I-405 Improvement Project  
**Amendment 1 - Noise Study Report**

*Seal Beach Tennis Court Center*

In Orange County from SR-73 to the I-605 Interchange

APRIL 13, 2012      FIGURE 23

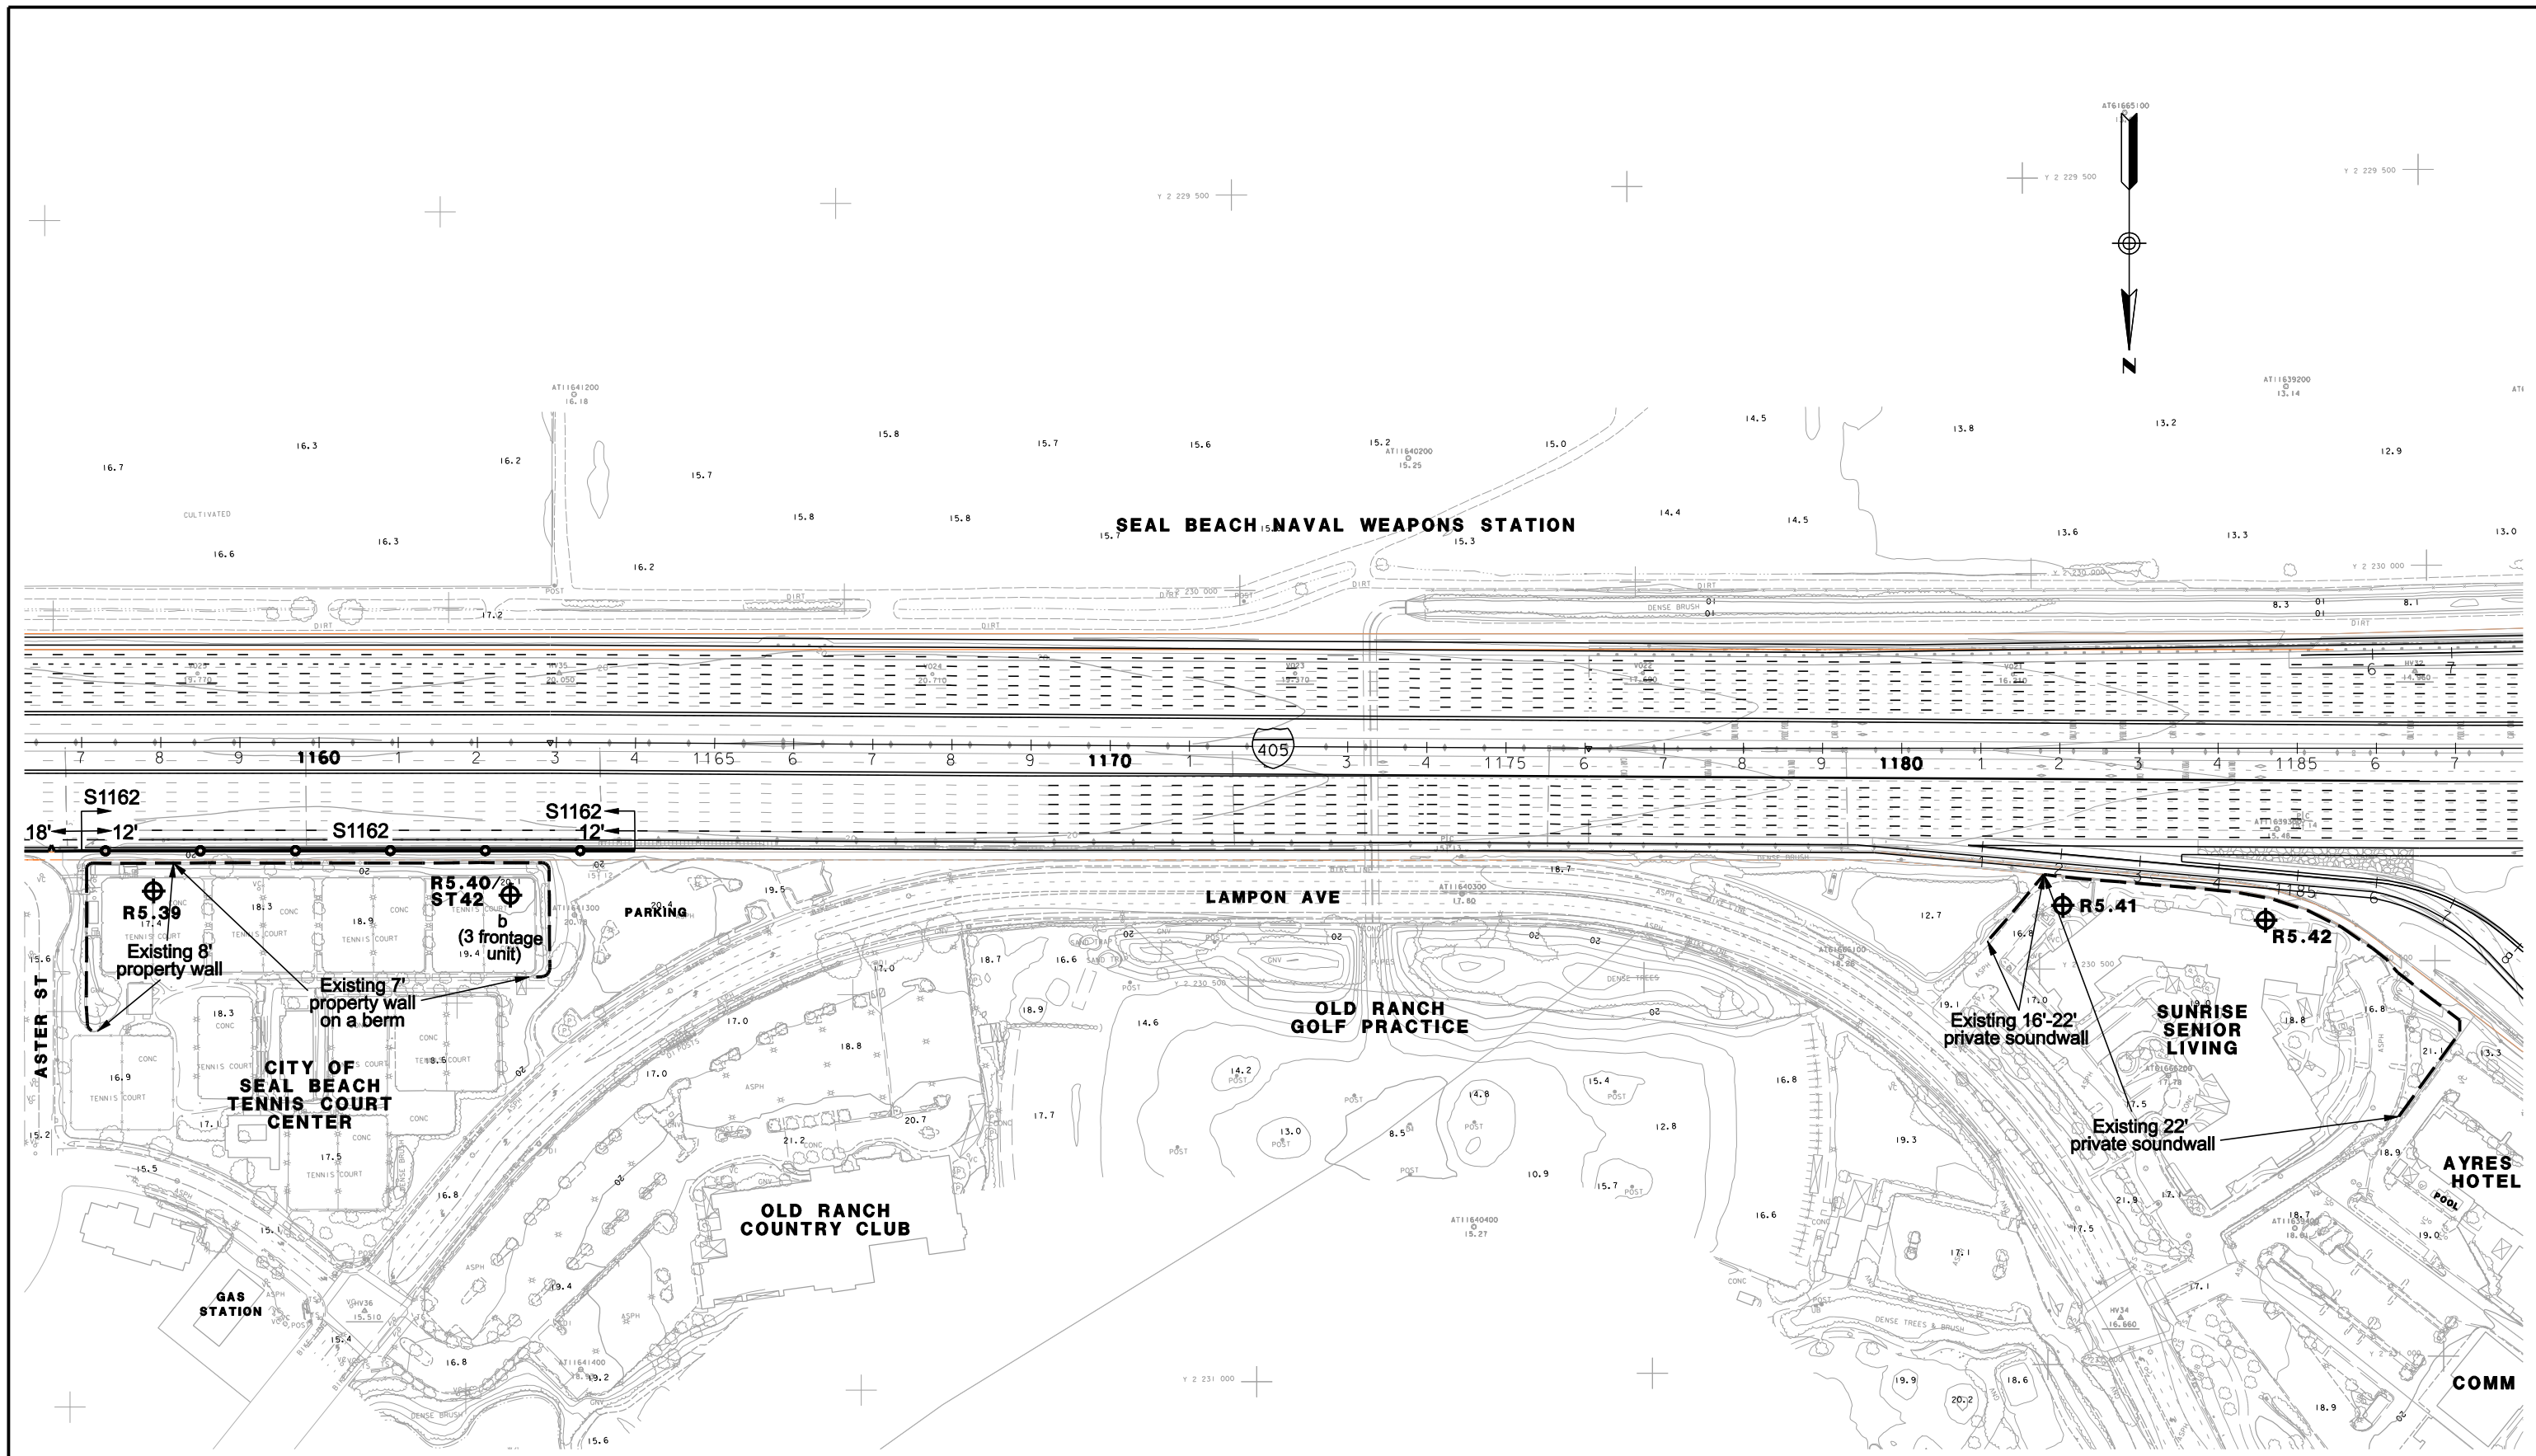
The final Noise Study Report dated June 2011 conducted for I-405 Improvement Project had identified Soundwall S1162 adjacent to the City of Seal Beach Tennis Court Center, as a feasible abatement measure for Alternatives 1, 2, and 3. However, NADR had concluded that this soundwall cannot be constructed within determined allowance for any build alternatives; therefore, it had concluded that this soundwall will not be considered reasonable for Alternatives 1,2, and 3. Upon further review it was determined that because the length of tennis court area along I-405 is approximately 550 feet, a higher number of benefited units –equivalent to benefited residence- can be considered for the noise analysis. As every 100 feet of exposed area is considered one frontage unit, six frontage units should have been considered in for the noise analysis instead of two.

The following are revised tables for each alternative that show the corrected frontage units and attached are corrected figures. It was assumed that Receivers R5.39 and R5.40 each represent three frontage units. NADR will also be revised to consider this correction.
